Historic Preservation Design Review

February 28, 2013

HP-13-01, 506 W. Hampton St. (City)

1. Install new windows

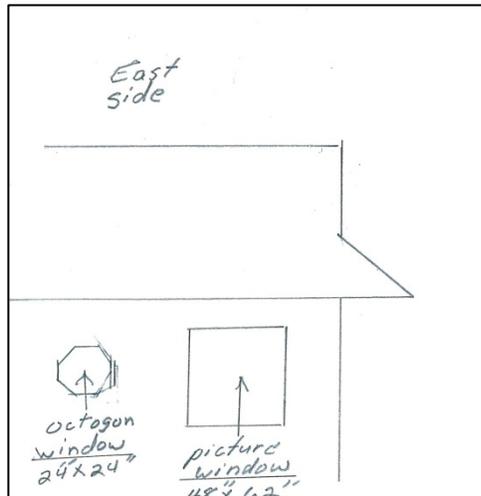
The proposed windows are shown in the photos below:

1. Installing 8 new windows (4) 32" x 52", (1) 32" x 36", (2) 48" x 62", (1) 24" x 24" octagon
 - Some of the windows proposed by the applicant are arched, and one of these has already been installed on the west façade of the structure as shown in the photo below.
 - Staff recommends denial of this portion of the request. The replacement windows should match as closely as possible the style, size and placement of the existing windows on the rear of the house (*see photo below*). Bungalow style windows are usually square or rectangular.

- 2. Install cedar siding**
- 3. Install tongue and groove flooring on porch**
- 4. Install plywood on porch ceiling**

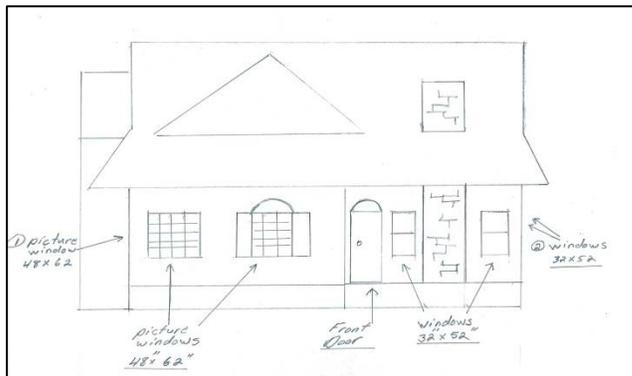
See samples submitted by applicant. The cedar siding and tongue and groove flooring are to match original.

2. Install 2000 feet of 1" x 6" cedar siding
 - Staff recommends approval of this material, to match existing.
3. Install 250 square feet of tongue and groove flooring on porch
 - Staff recommends approval of this material to match the style of what was removed previously.
4. Install BC Plywood on porch ceiling
 - Staff recommends approval.
